DECISION OF THE SALEM PLANNING COMMISSION

CLASS 3 DESIGN REVIEW / CLASS 3 SITE PLAN REVIEW / SOUTH WATERFRONT MIXED-USE ZONE DEVELOPMENT PHASING PLAN MODIFICATION / CLASS 2 ADJUSTMENT / CLASS 2 DRIVEWAY APPROACH PERMIT CASE NO.: DR-SPR-SWMUDPP-ADJ-DAP21-01

SUMMARY: An application for a proposed new four-story mixed-use building consisting of a 72-bed post-acute rehabilitation facility and approximately 3,940 square feet of ground floor commercial space at the corner of Commercial Street SE and Front Street SE.

L3.01

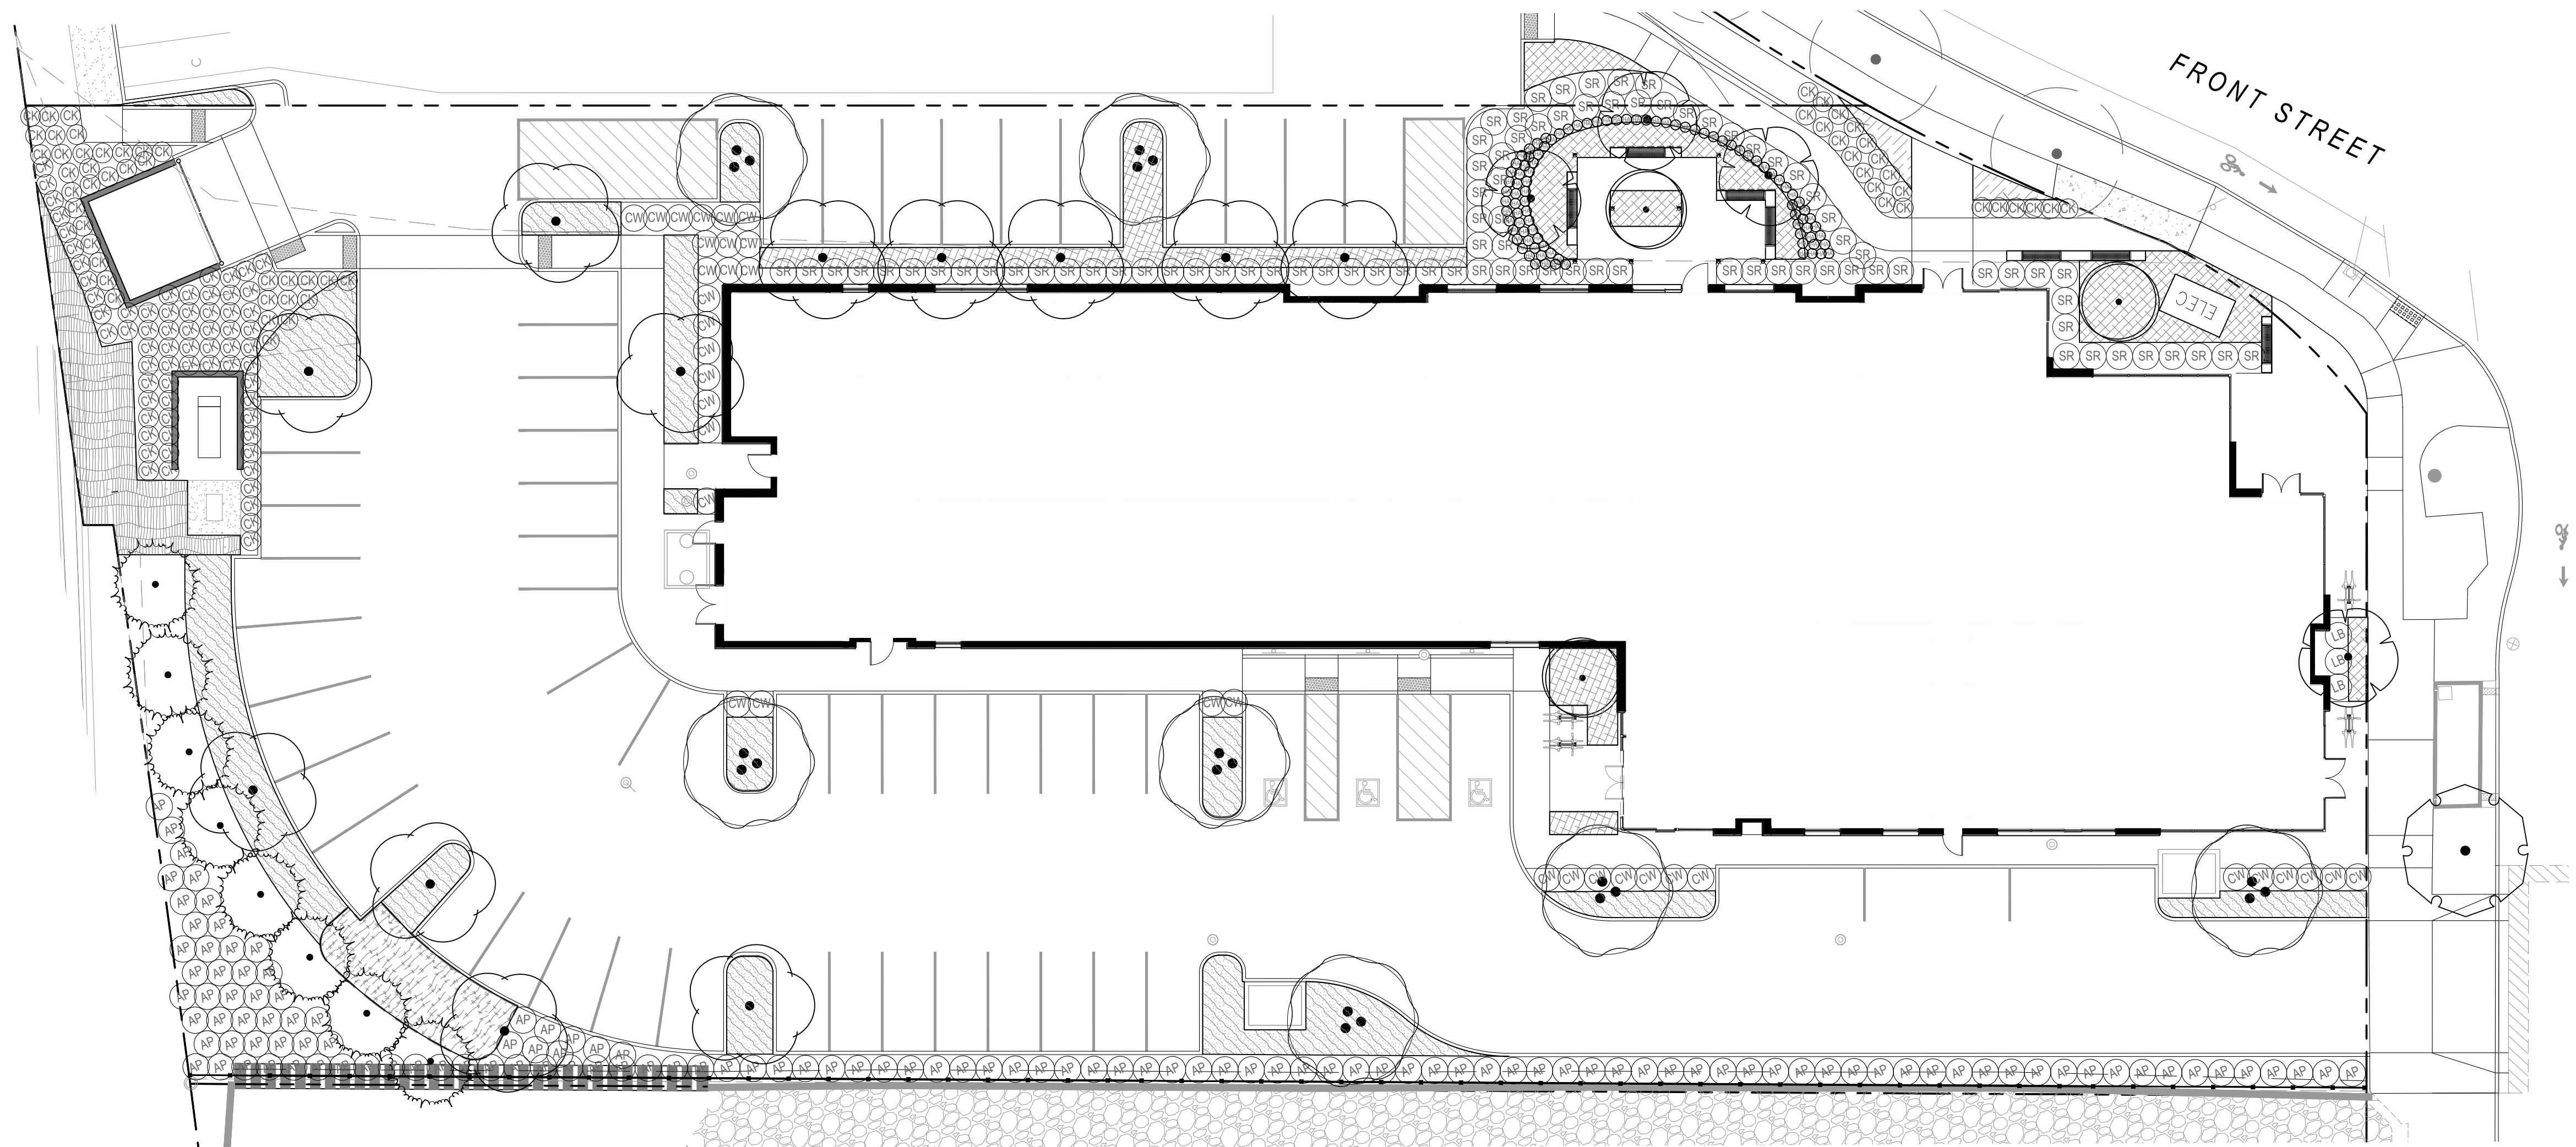
In order to buffer the proposed driveway and parking area located on the south side of the property from the creek corridor and to create a well-framed open space environment along the creek, a combination of landscaping and trees, where space allows, is provided. As shown on the landscape plan and indicated in the applicant's written statement, the proposed shrubs provided along the southern property line include Greenleaf Manzanita that grow three feet to six

feet in height. Because Greenleaf Manzanita produce fruits/berries that can pose a potential long-term maintenance issue for the future adjacent pedestrian path to the south, staff originally recommended the following condition of approval requiring an alternative species of evergreen shrub to be planted that would provide the same degree of buffering/screening between the driveway and parking area and south property line, but which would not have the same potential long-term maintenance issue.

Condition 1: *The landscaping plan shall be revised to replace the Greenleaf Manzanita proposed along the southern property line with an alternative sight-obscuring evergreen shrub, or variety of evergreen shrubs, that will grow to a height of 3 feet to 6 feet and not produce fruits/berries.*

Upon consideration of the above recommended condition, the Planning Commission found the concerns for future potential maintenance issues associated with the future pedestrian path unnecessary due to the limited height of the hedge, the small size of the berry, and the horizontal separation that will exist between the proposed planting area and the future path; thereby minimizing any potential maintenance issue. In addition, the Planning Commission found that the Greenleaf Manzanita is a native species that provides bird and caterpillar/butterfly habitat which is of benefit to the City. For these reasons the Planning Commission voted to remove Condition 1 of the design review approval and found that the proposal conforms to this design guideline without the condition of approval.

**TENTATIVE COMPOSITE
UTILITY PLAN**

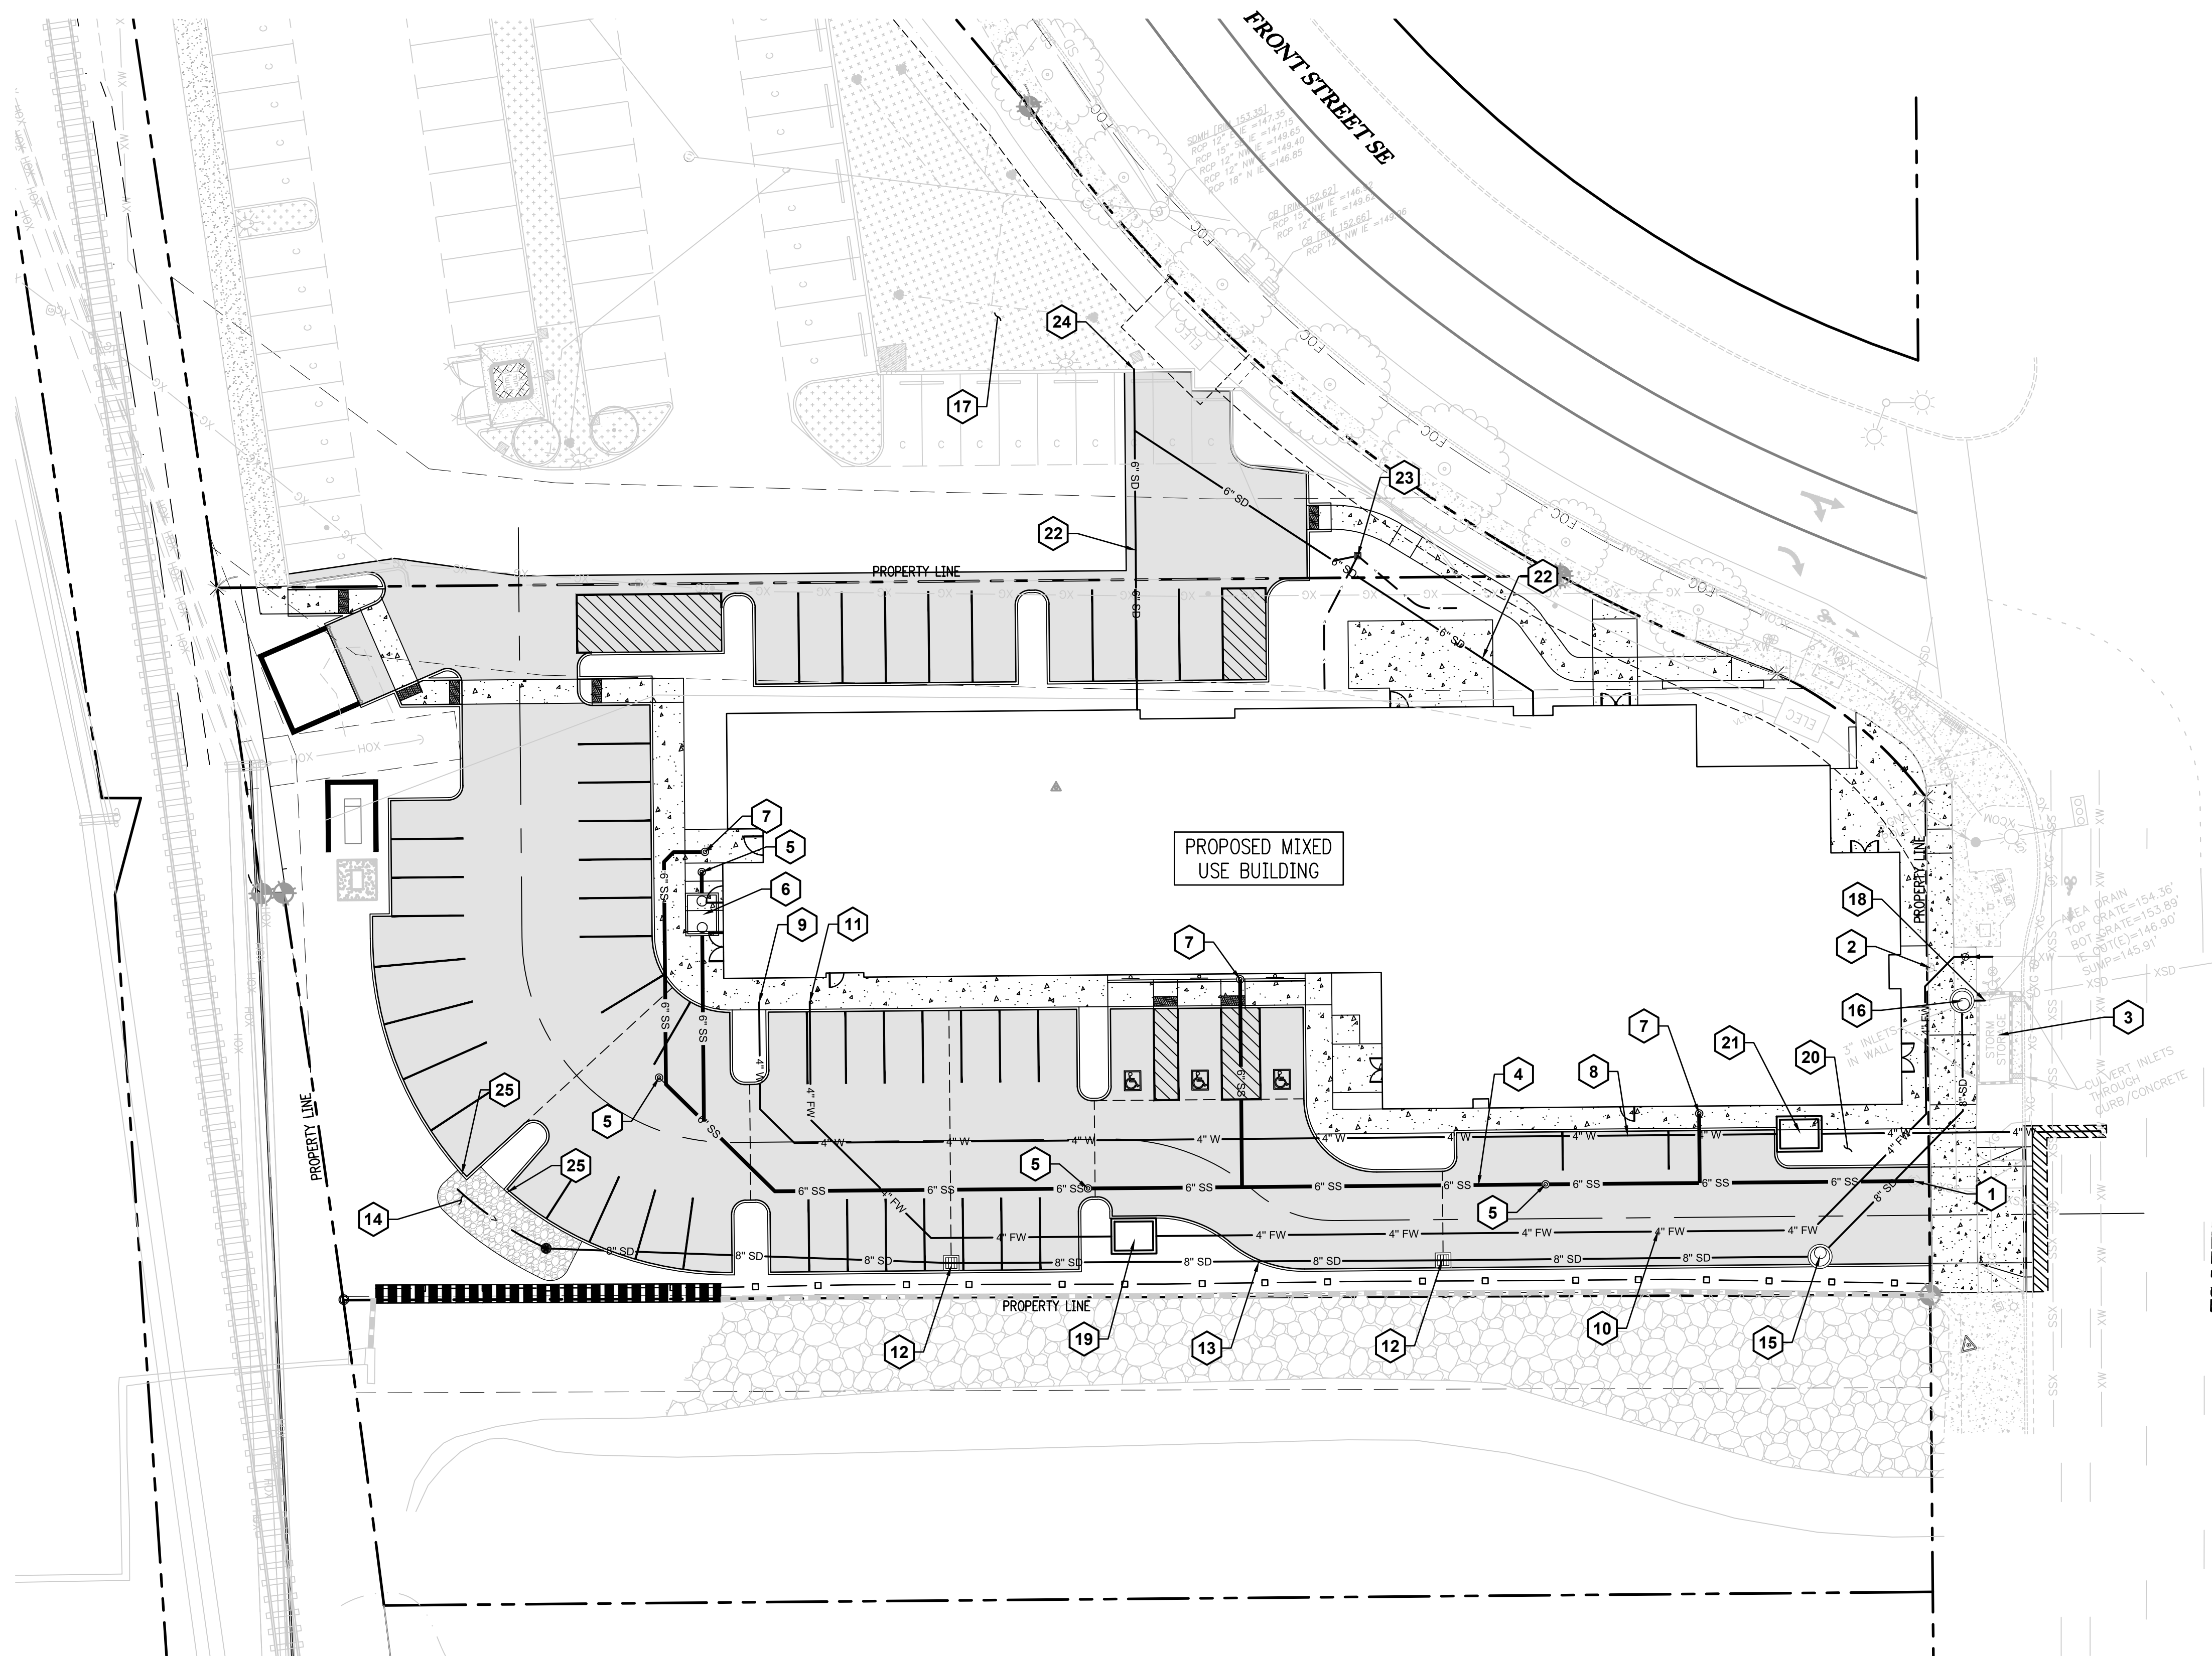
In regard to stormwater facilities, the preliminary stormwater design demonstrates the use of green stormwater infrastructure. However, initial City review of the preliminary design demonstrates that additional changes may be needed to provide sufficient capacity for flow control and treatment. Given the proximity of the subject property to the Willamette River, the applicant may be able to obtain approval from the Public Works Director for a fee-in-lieu of improvements pursuant to SRC 71.025. In order to ensure that the proposed development will be adequately served with stormwater facilities, the following condition of approval shall apply:

Condition 4: Design and construct a storm drainage system at the time of development in compliance with Salem Revised Code (SRC) Chapter 71 and the Public Works Design Standards (PWDS) in effect at the time of application submittal or obtain approval from the Public Works Director for a fee-in-lieu of improvements pursuant to SRC 71.025.
